Access Compliance Report

Public Rights-of-Way

Intersection ID: 45496	Main Street: COTTON_PRESS_RD	Cross Street: COTTON_STAND_RD	Location:	N
ADA ID: 7BA5900BB6BE	Ramp Type: PerpDiag	Initial Pass/Fail: Fail	Overall Compliance: No	Severity Score: 22.5
Codes/Mitigation Info/Possible Solution		Field Measurements/Component Compliance

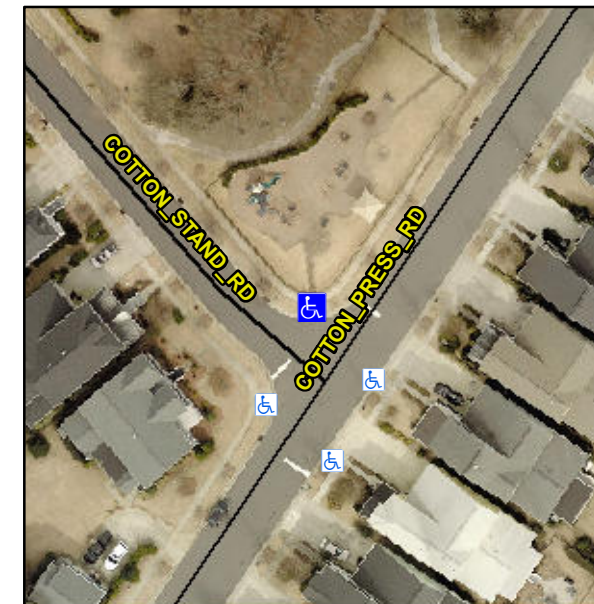
Not Found, R304.5.1, R304.2.2, R304.5.3

Compliance	Description	Data	Compliance	Description	Data
N/A	Ramp Length (in)	73.0	No	Ramp Slope (%)	8.6
No	Ramp Width (in)	36.0	No	Ramp XSlope (%)	2.2
N/A	Flare Type LT	N/A	N/A	Flare Type RT	N/A
N/A	Flare Slope LT (%)	N/A	N/A	Flare Slope RT (%)	N/A
N/A	Flare Traversable LT?	N/A	N/A	Flare Traversable RT?	N/A
N/A	Landing Length (in)	N/A	N/A	DWS Provided?	N/A
N/A	Landing Width (in)	N/A	N/A	DWS Contrast?	N/A
N/A	Landing Slope (%)	N/A	N/A	DWS Length (in)	N/A
N/A	Landing X Slope (%)	N/A	N/A	DWS Full Width?	N/A
N/A	Landing Curb? (Y/N)	N/A	N/A	DWS Offset (in)	N/A
N/A	Shared Landing?	N/A			
N/A	Gutter Ponding?	N/A	N/A	Gutter Slope (%)	N/A
N/A	Gutter Lip Ht (in)	N/A	N/A	Gutter X Slope (%)	N/A
N/A	Painted X Walk1?	No	N/A	Painted X Walk2?	No
	X Walk 1 Direction	To SW		X Walk 2 Direction	To SE
N/A	X Walk 1 Width (in)	N/A	N/A	X Walk 2 Width (in)	N/A
	X Walk 1 Slope (%)	0.9		X Walk 2 Slope (%)	0.0
	X Walk 1 X Slope (%)	2.4		X Walk 2 X Slope (%)	0.7

Remove & Replace Curb Ramp With Two New Directional Ramps or Equivalent.
